MEMORANDUM

SUBJECT: Construction of a two slip boat dock at 666A Big Horn Drive,
File No. SP-97-0462DS (Morrissey Boat Dock)

Morrissey Boat Dock, 666A Big Horn Drive
File # SP-97-0462DS

Barnes & Skrudland Bulkheads

SITE PLAN SCALE 1"=30'

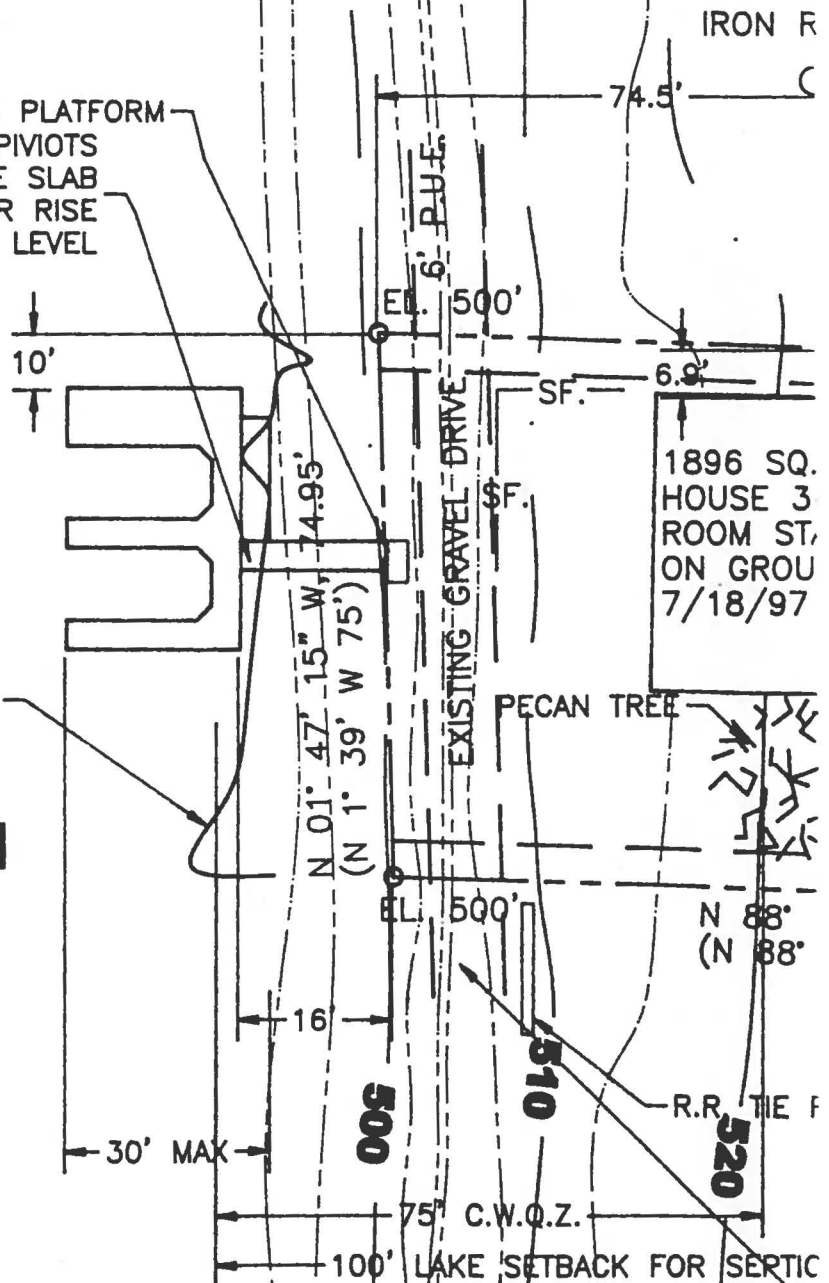
1. A location plan should be provided indicating the location of the project on Lake Austin.
2. The location of the shoreline should be accurately indicated on the plans.

3. The actual location of the proposed dock along the shoreline should be shown on the plot plan. Be advised that there is a 10' wide adjacent side property line setback that prohibits construction.

4. The proposed dock is shown to extend 44' from the shoreline. Section 13-2-795(1) restricts the length of structures extending into the water to a maximum of 30'. The Board can approve construction to a greater distance if requested in a letter submitted with the application. However, there must be mitigating circumstances and these circumstances must be detailed and/or demonstrated in the request letter. Specific conditions that will be reviewed before considering a request include navigational safety, for example how far do the adjacent docks extend into the lake?

5. Navigation light stations, in accordance with 13-2-794 of the City's Land Development Code must be provided on the structure. If the boat dock structure is longer than 30' or wider than 25', additional light stations shall be provided at the external corners around the lake side perimeter of the structure at a distance not to exceed 25' apart.

6. All lights, with the exception of the navigation lights, shall be shielded so as not to shine light over the water.
7. The proposed coating of the steel pilings with bituminous paint may have an adverse impact on water quality. If it is intended that bituminous paint will be used, written approval of the City's Environmental Department will be required.

The Navigation Committee also noted that the proposed boat dock was located at the upper end of Lake Austin. During major discharges from Mansfield Dam the water elevation in this area can rise 10' and be at significant velocities. Consideration should be given to bracing the boat dock structure and the pilings to provide additional resistance to the water during these events.

The plan was reviewed January 8, 1998 but was returned as being incomplete. A revised plan has been submitted with the following: it shows a location plan, the shoreline location, a 10' setback from the property line, extension from the shoreline of no more than 30', and an adequate number of navigation lights which will be shielded so as not to shine directly over the water. Outstanding is approval by the Planning, Environmental and Conservation Services Department (PECSA) on an appropriate paint to coat the steel pilings. With these modifications the project will meet the requirements of Article VI, Division 4, Part E (Requirements for the Construction of Boat Docks) of the Land Development Code (including all amendments).

TYPICAL BULKHEAD SECTION

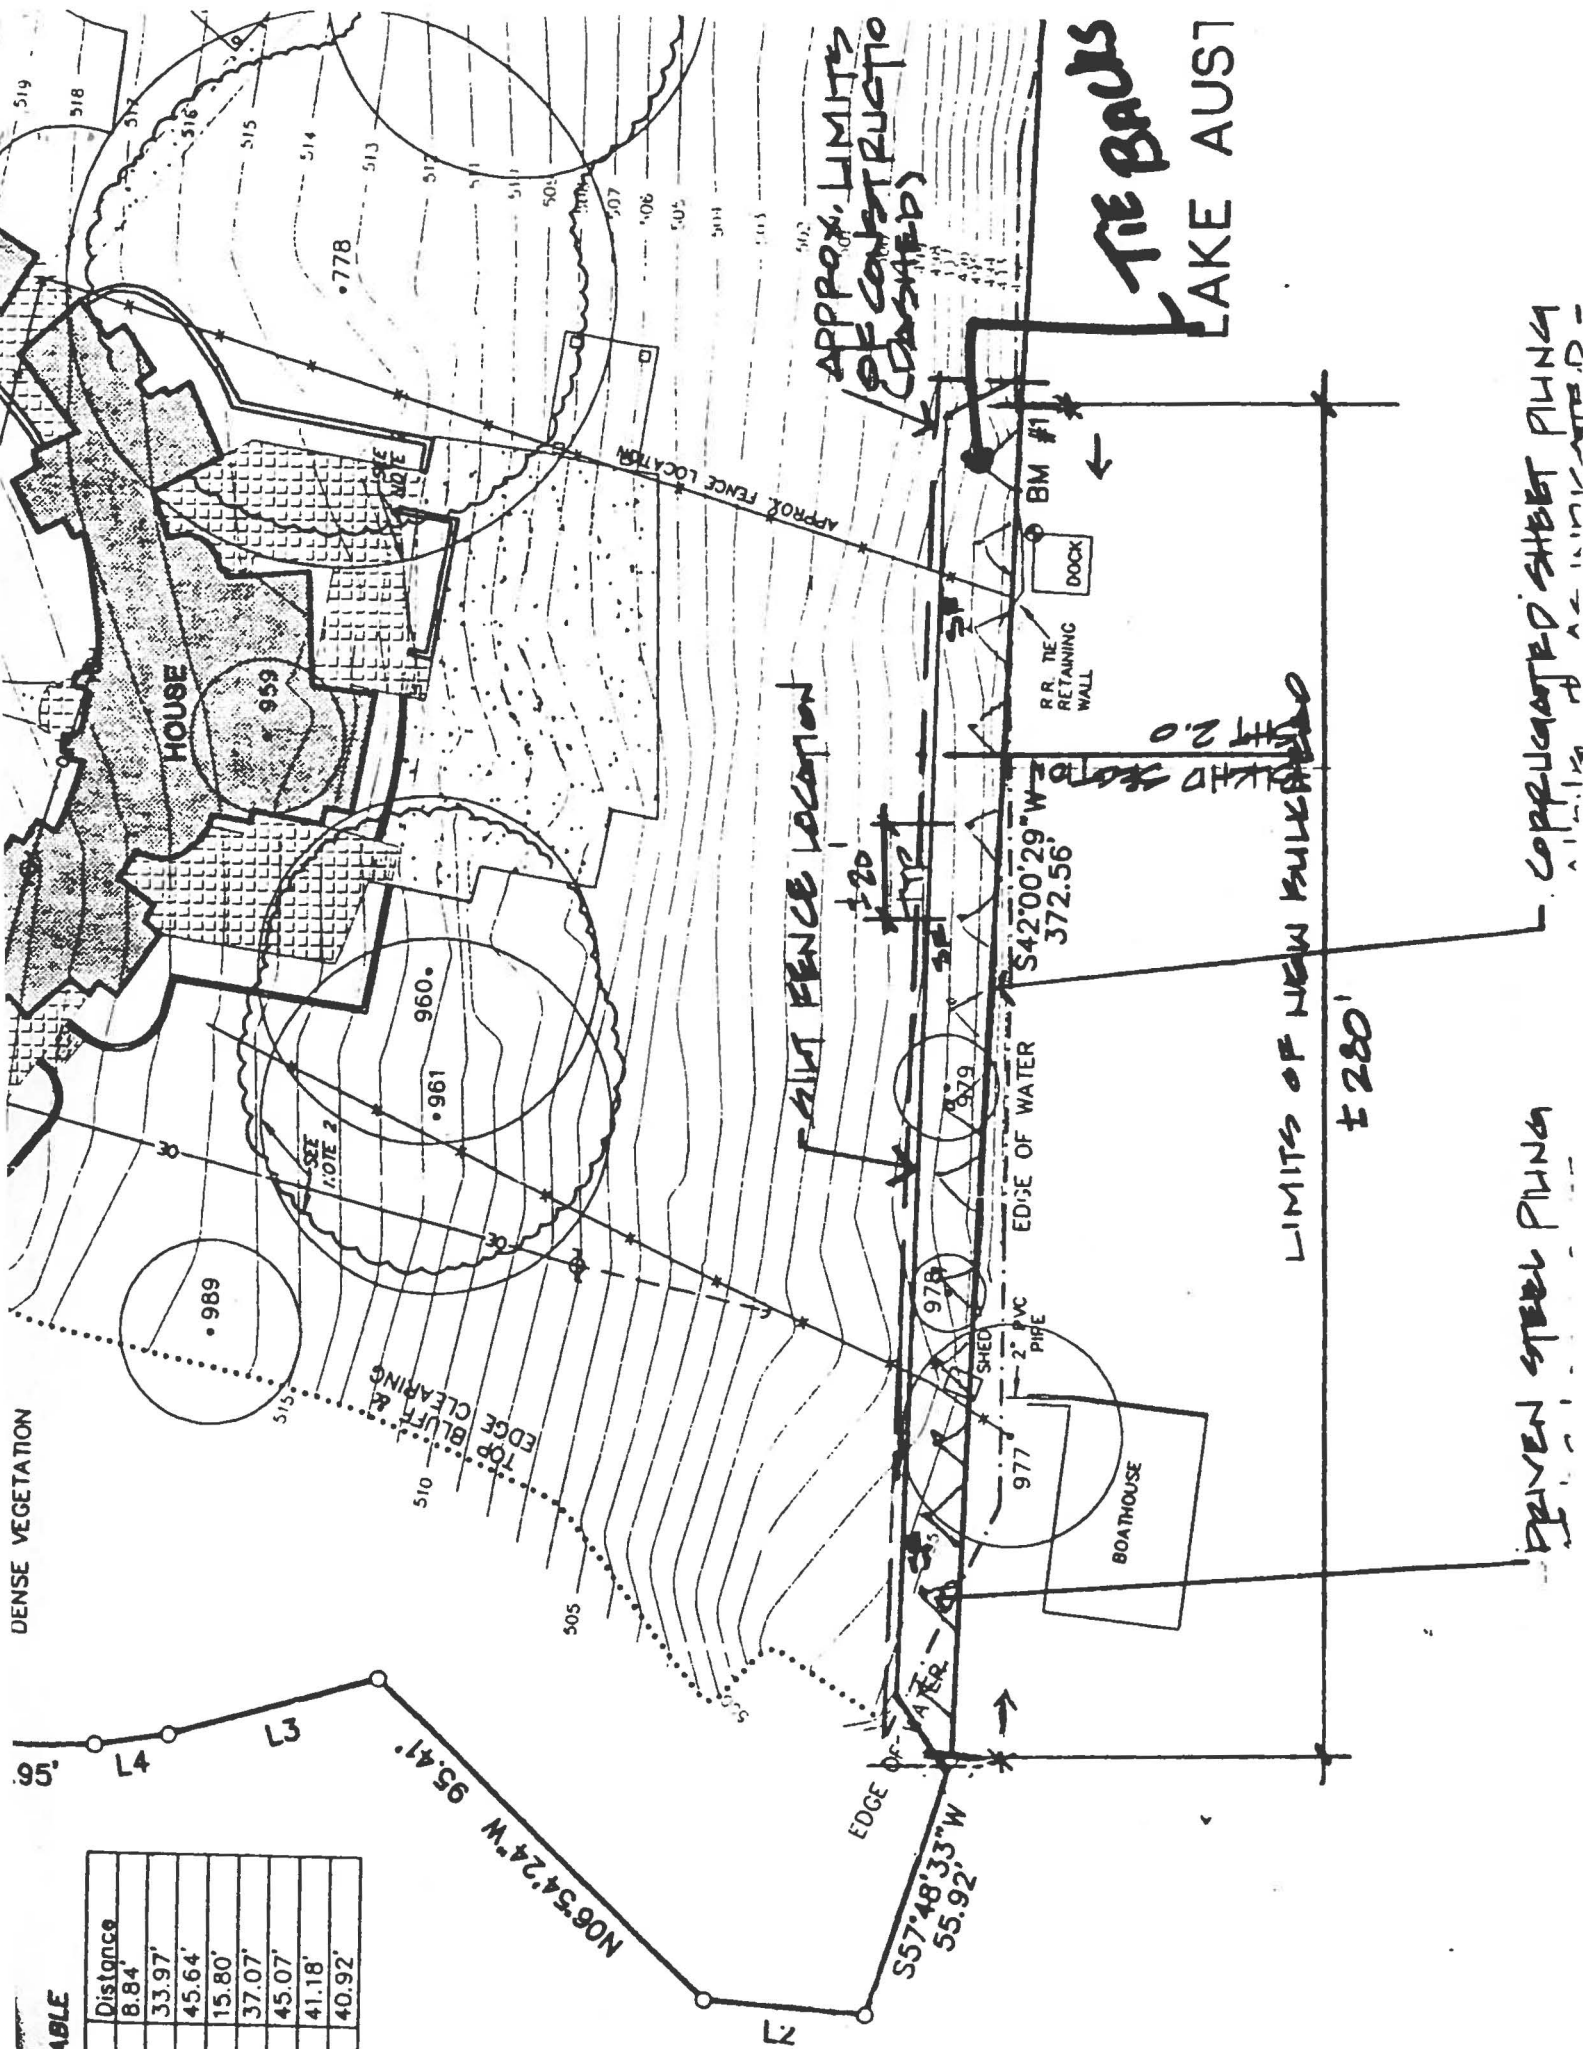
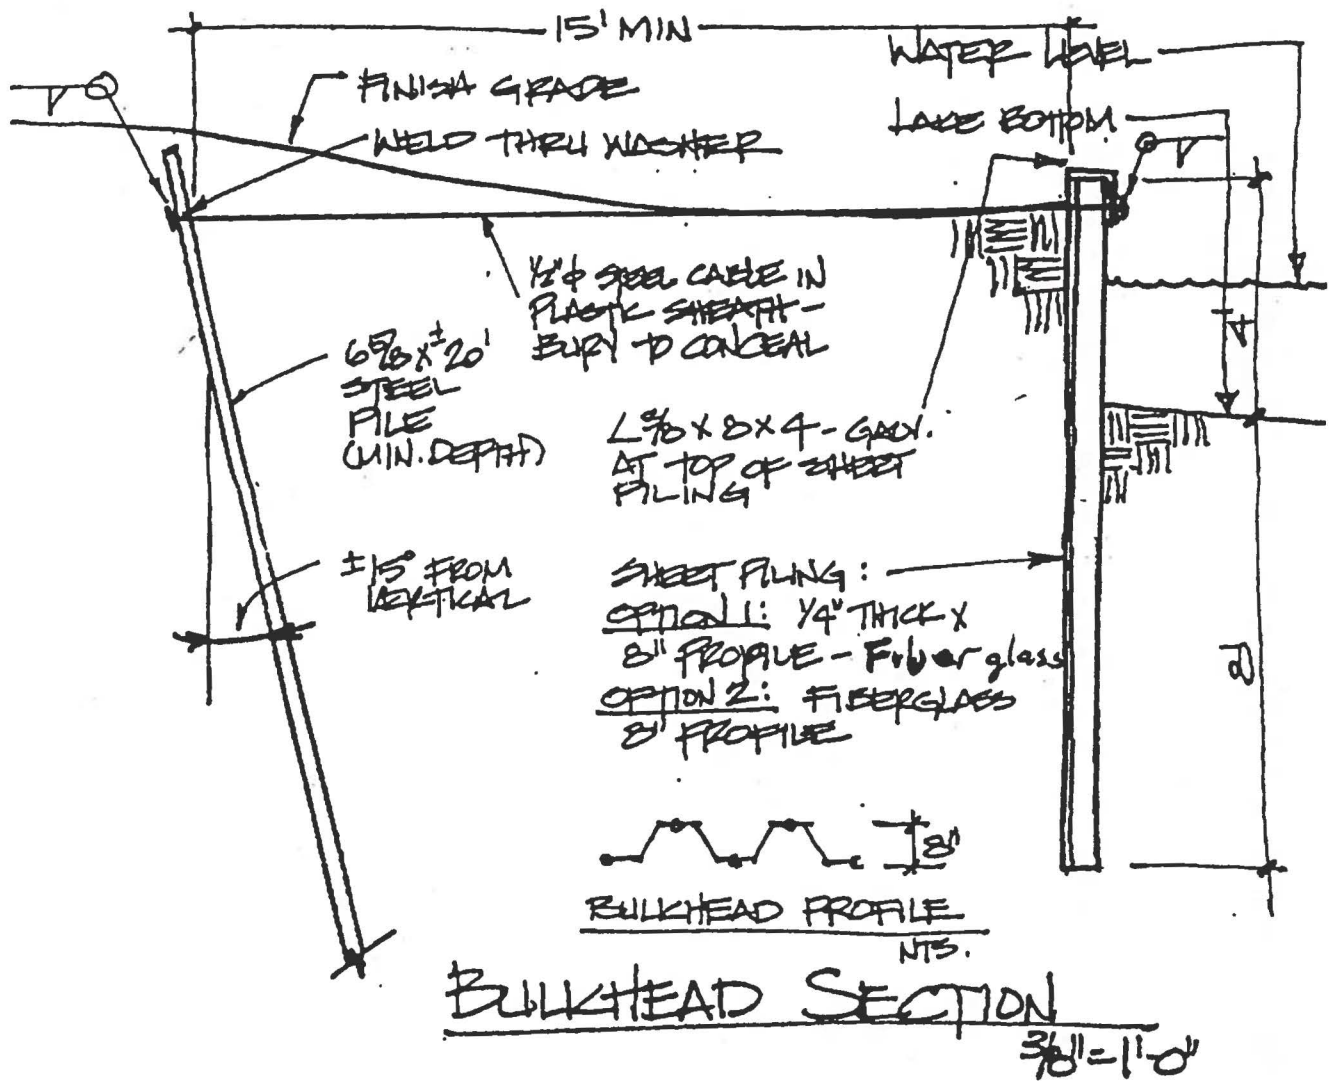
The Parks and Recreation Department (PARD) staff has reviewed the project and the site plans meet the requirements of Article VI, Division 4, Part E (Requirements for the Construction of Boat Docks) of the Land Development Code (including all amendments), except that the plans do not clearly indicate that the bulkhead is to be built at the existing shoreline and that returns will be constructed at both ends to anchor the bulkhead. Assurances must be submitted to clarify these issues.

This letter is to address the issue of the bulkhead detail concerning how it ties into the end.
The bulkheading will have a 10' Bulkhead return tie back on each end.

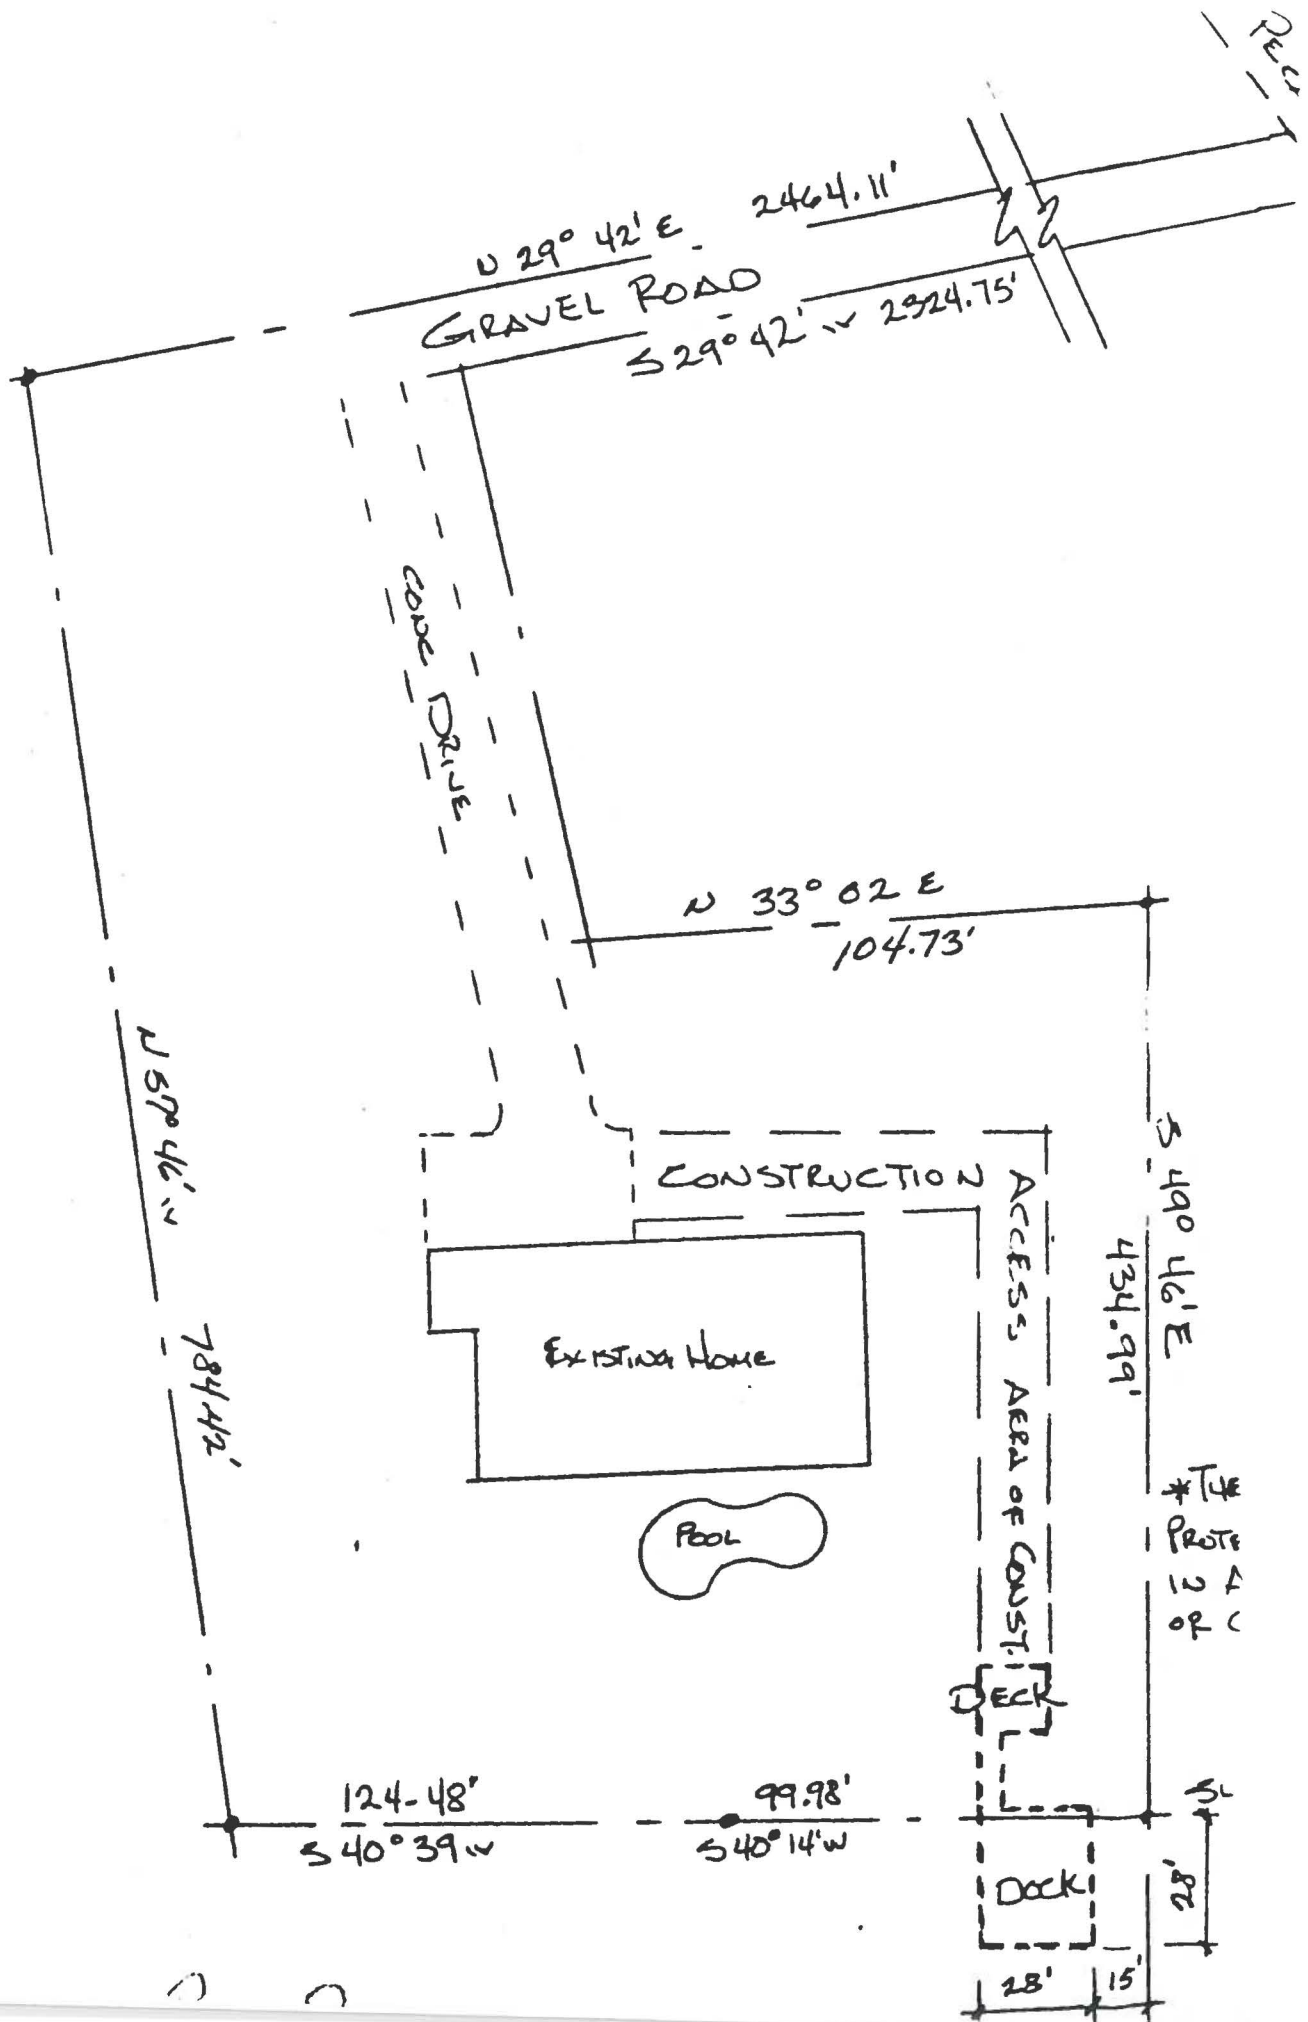
The plan was reviewed by the Parks and Recreation Department (PARD) staff and the site plans meet the requirements of Article VI, Division 4, Part E (Requirements for the Construction of Boat Docks) of the Land Development Code (including all amendments), with the exception of navigation light stations on the exterior corners, and cross bracing on the pilings below the water line. The dock is located near Mansfield Dam and is subject to flooding and high flows during discharges from the dam.

1. Navigation light stations be provided on the external corners of the boat dock in accordance with Section 13-2-793 of the City Land Development Code.
2. Cross bracing be installed on the pilings below the water line.
3. The revised site plan be submitted to PARD staff for review and approval.
